# 33 Cross Street

OVERLOOKING STUDY

FEBRUARY 2025

## ASSESSMENT LEVEL TWO - WEST

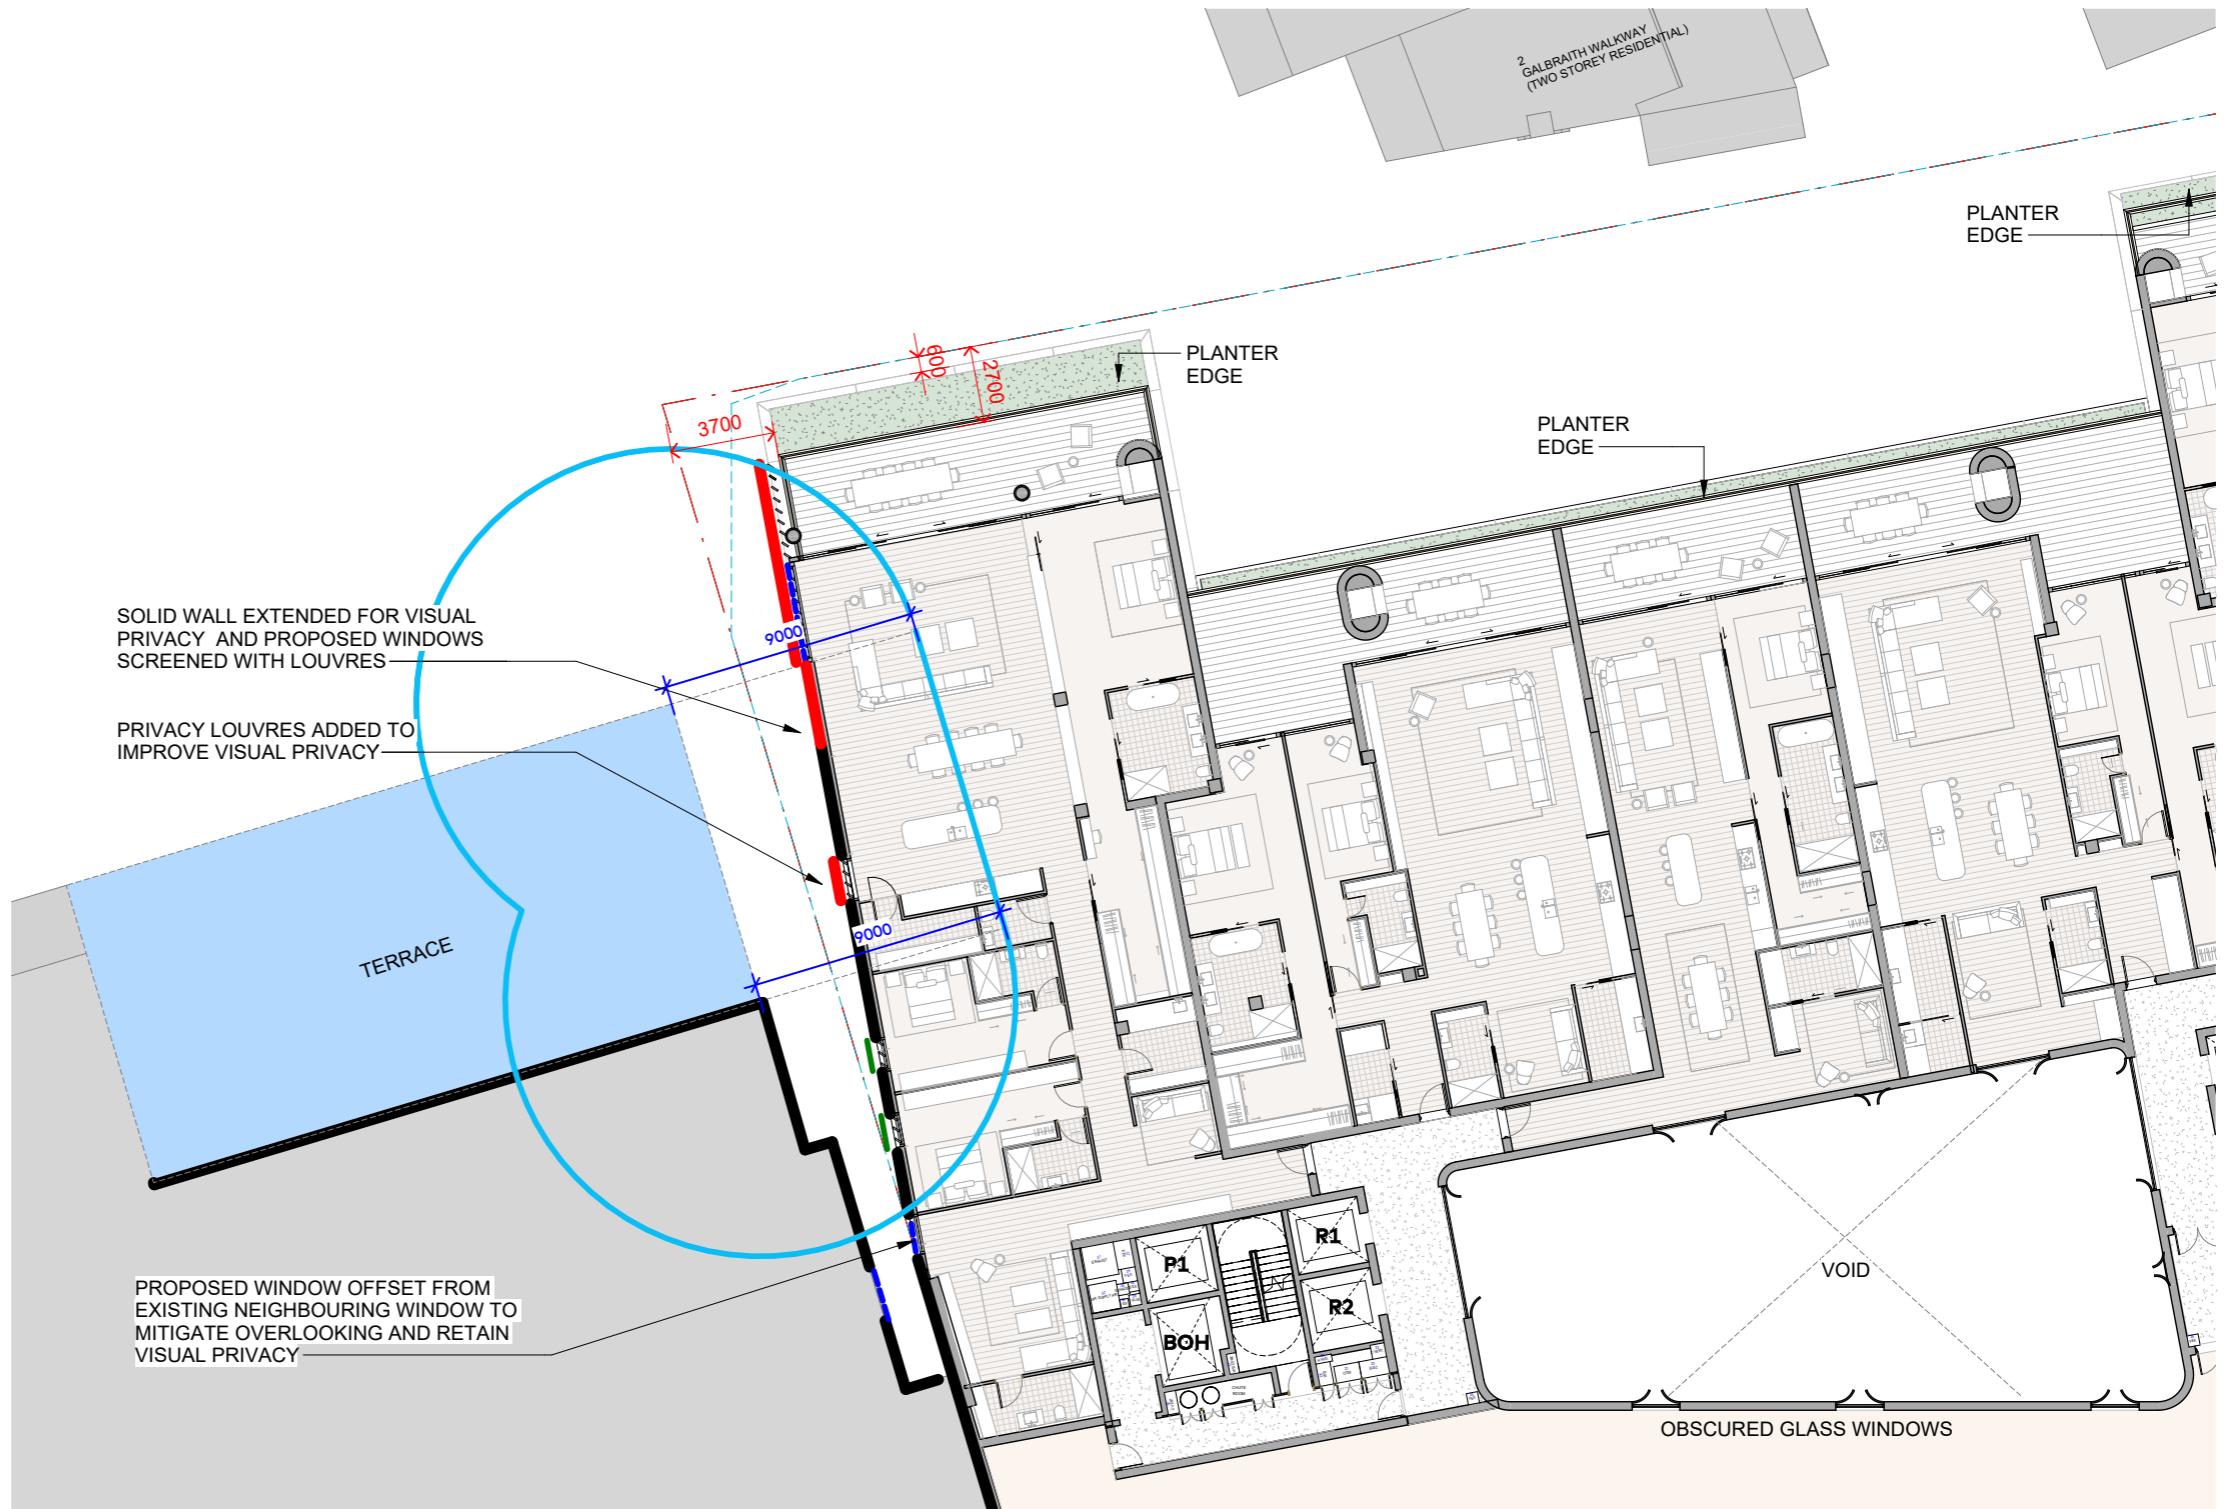
**GSA HAS CONFIRMED THAT LOUVRED WINDOWS AND OFFSET  
WINDOWS CAN COMPLY  
ADDITIONAL SOLID WALL INCORPORATED TO COMPLY**

ABOVE GROUND:  
9M BETWEEN OUR WINDOWS  
AND NEIGHBOURING  
TERRACES/WINDOWS

## ASSESSMENT WEST FACADE

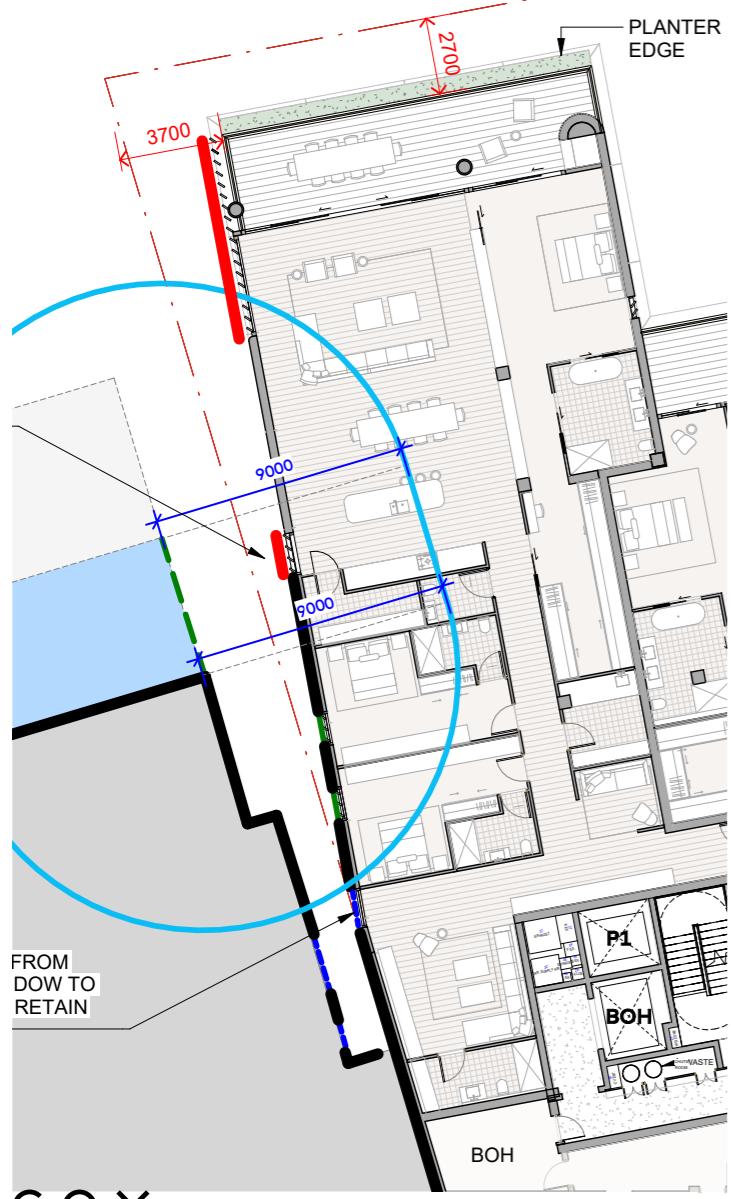
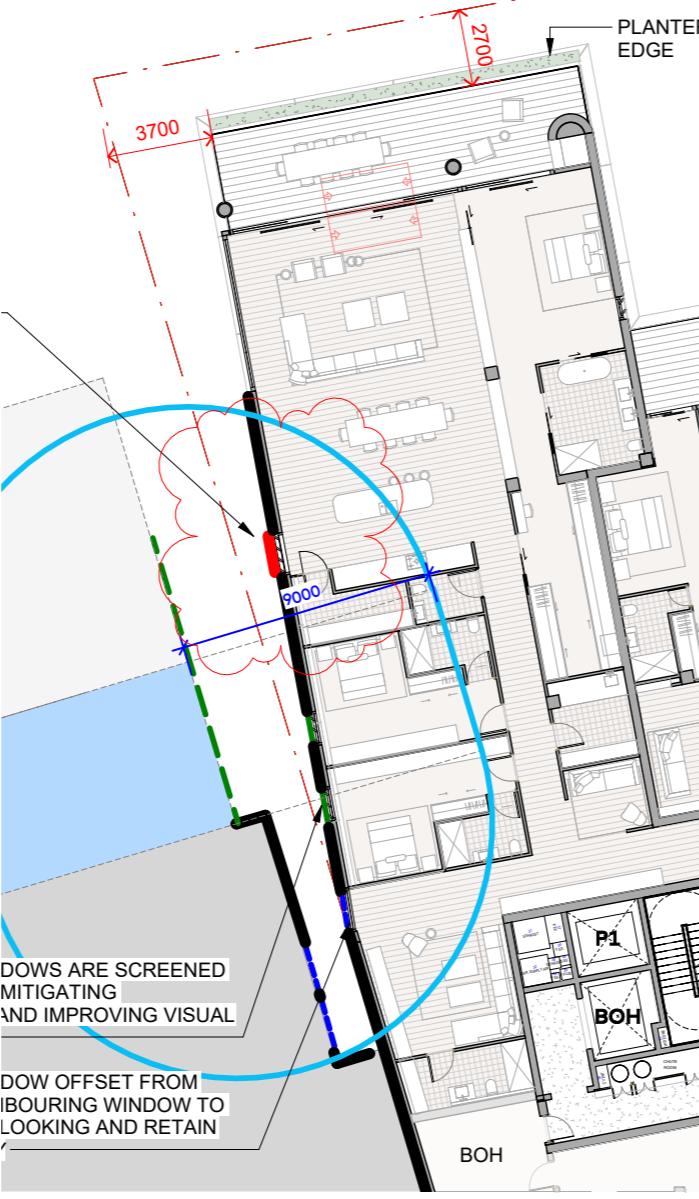
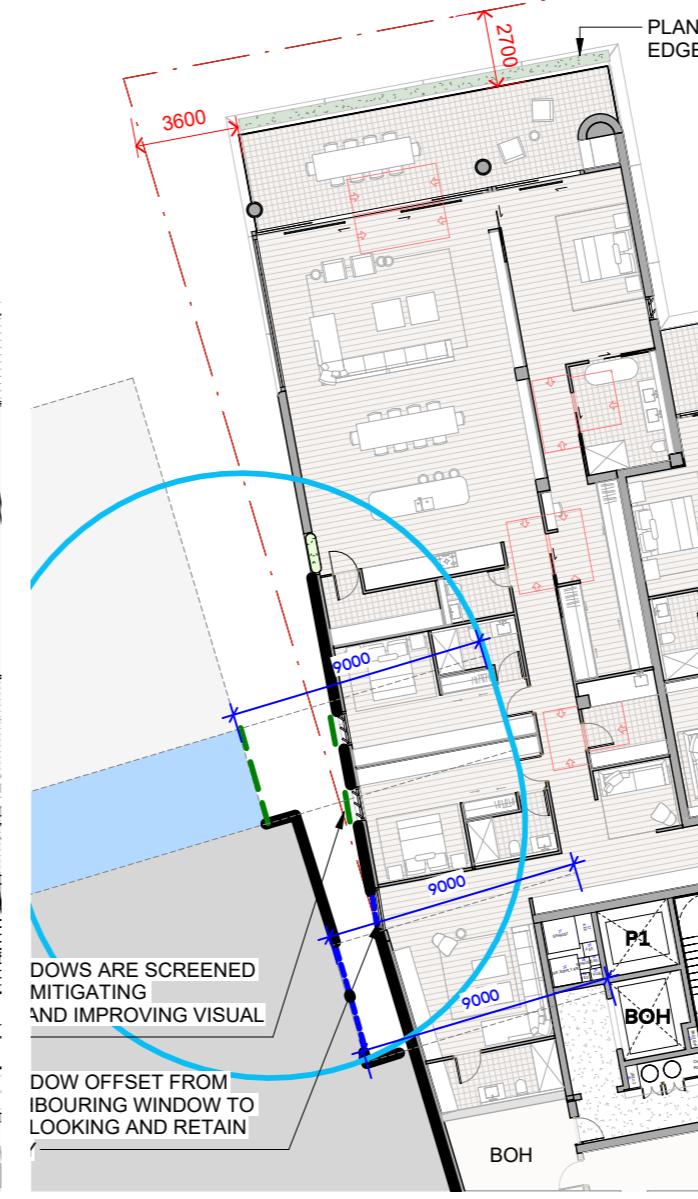
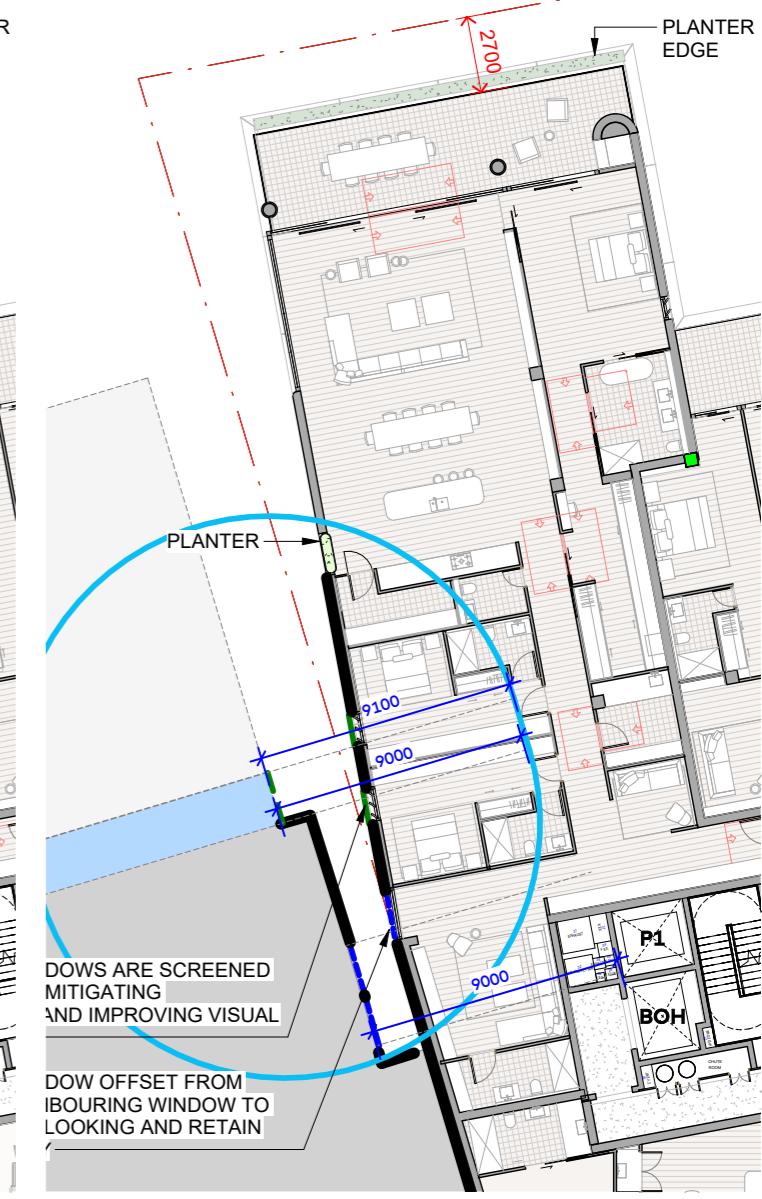
## NEW PROPOSED BUILDING ELEVATIONS TO BE PROVIDED NEXT WEEK WITH FINAL DESIGN AMENDMENTS

REDUCED GLAZING + TERRAZZO BLADES

TERRAZZO BLADES

# ASSESSMENT NORTH RESIDENTIAL TERRACES

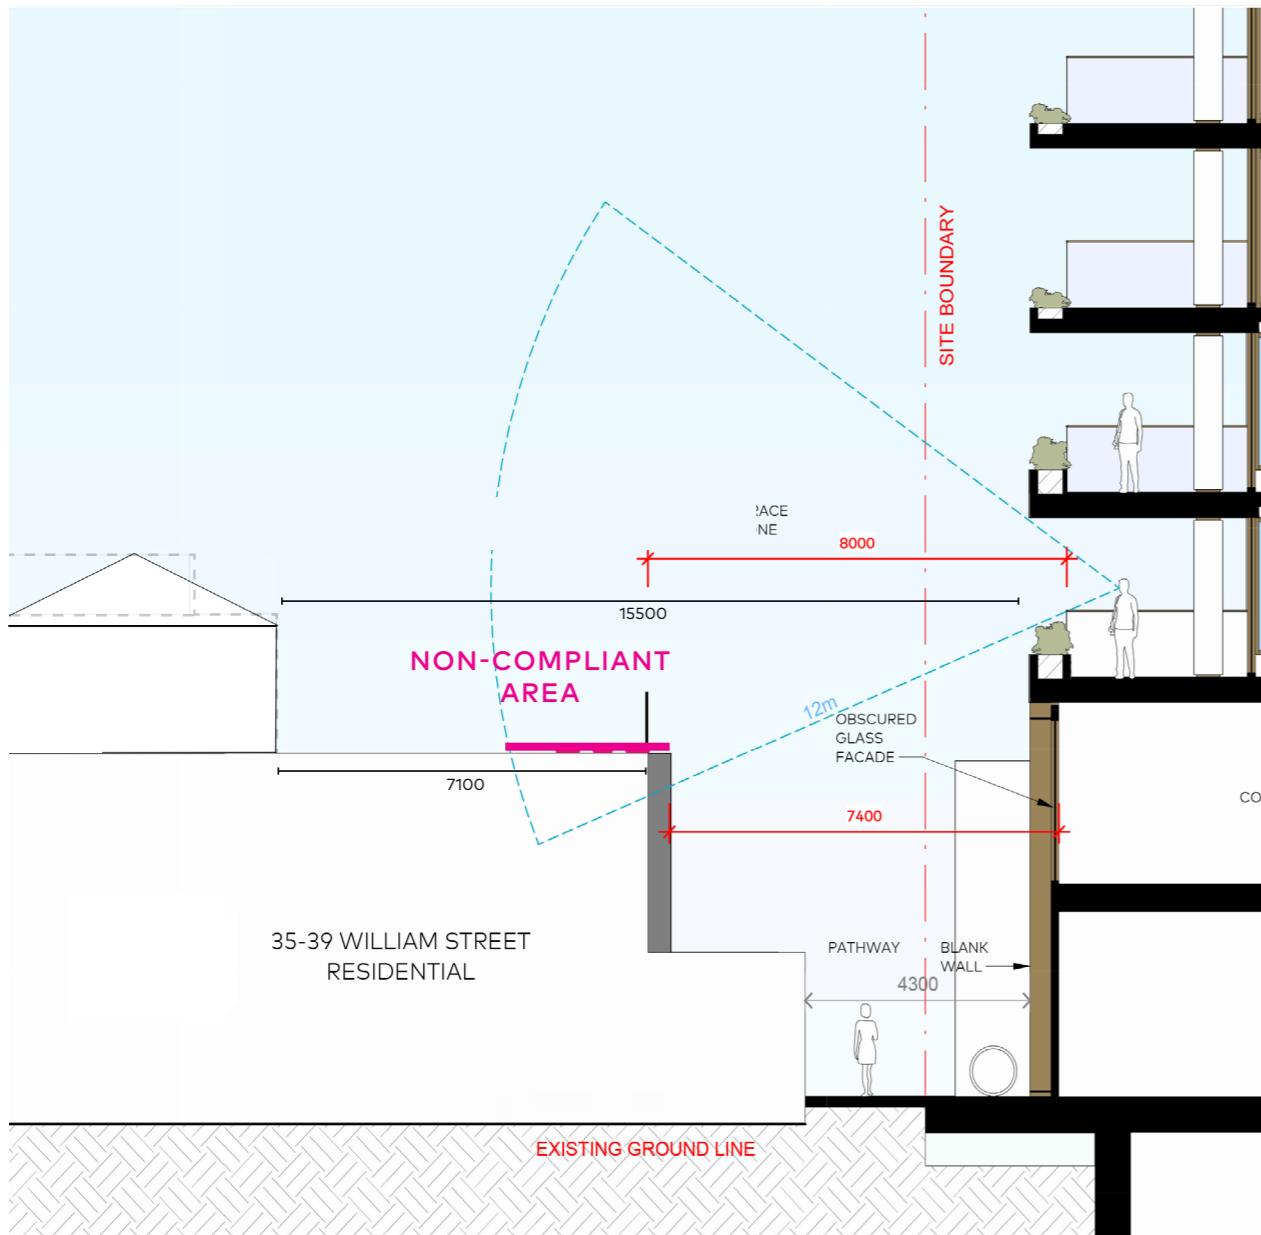
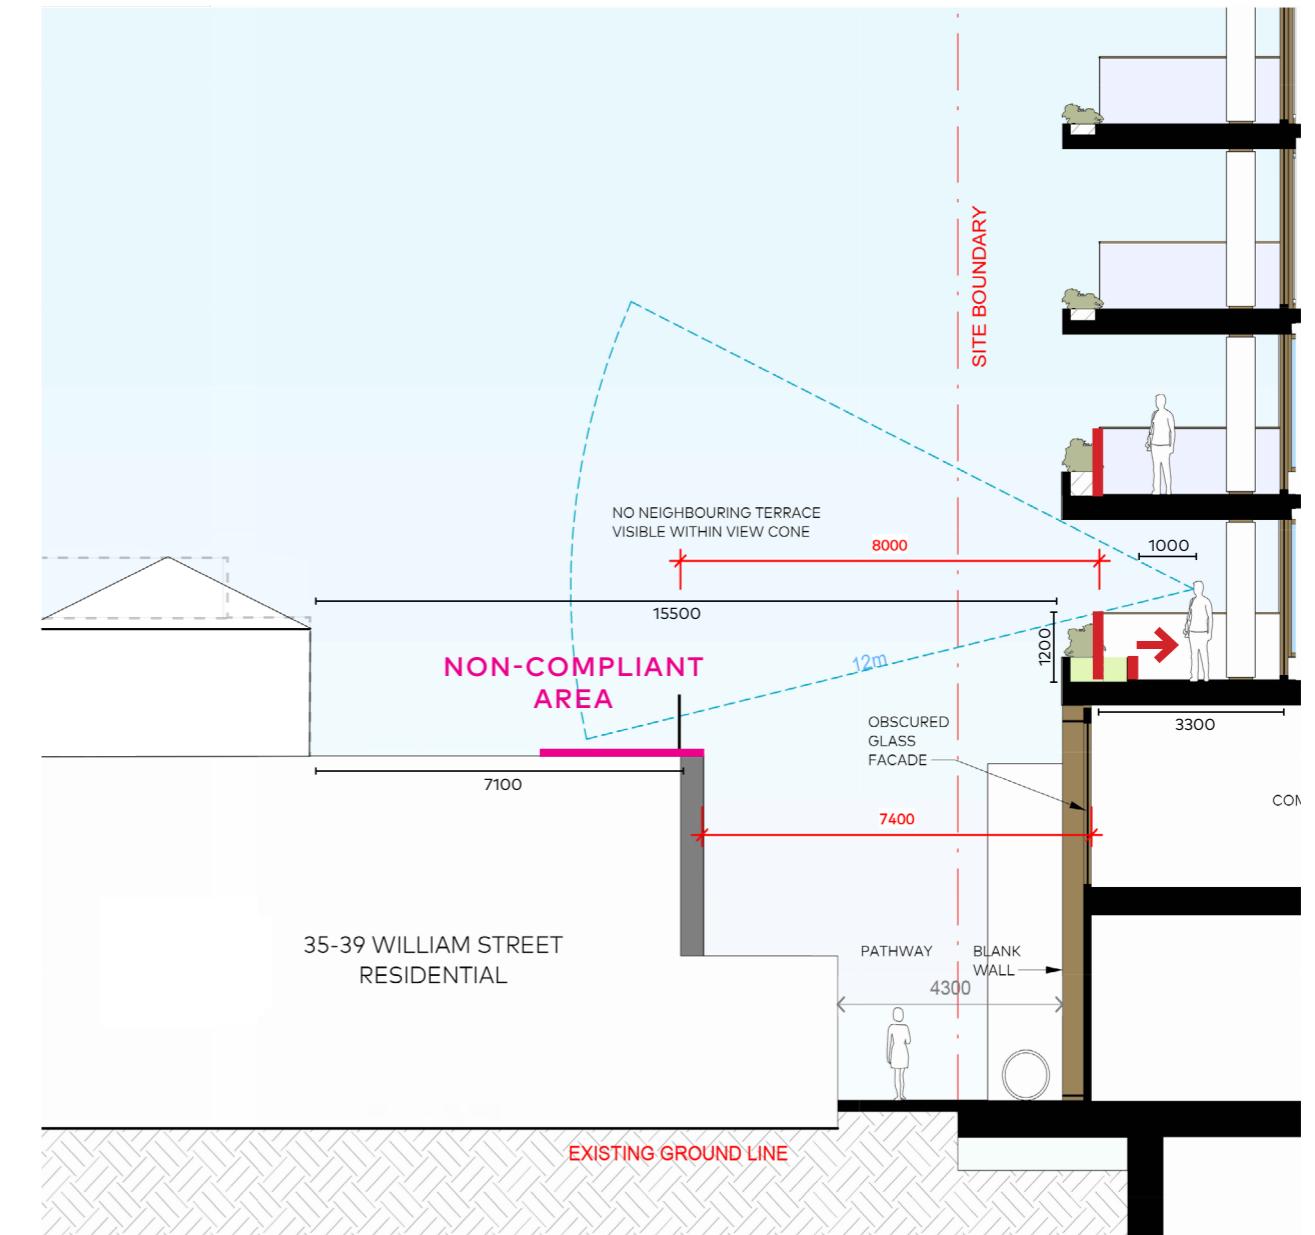
PUSH PLANTER BACK 800MM, CHANGE  
BALUSTRADE TO SOLID, BALCONY DEPTH 3M
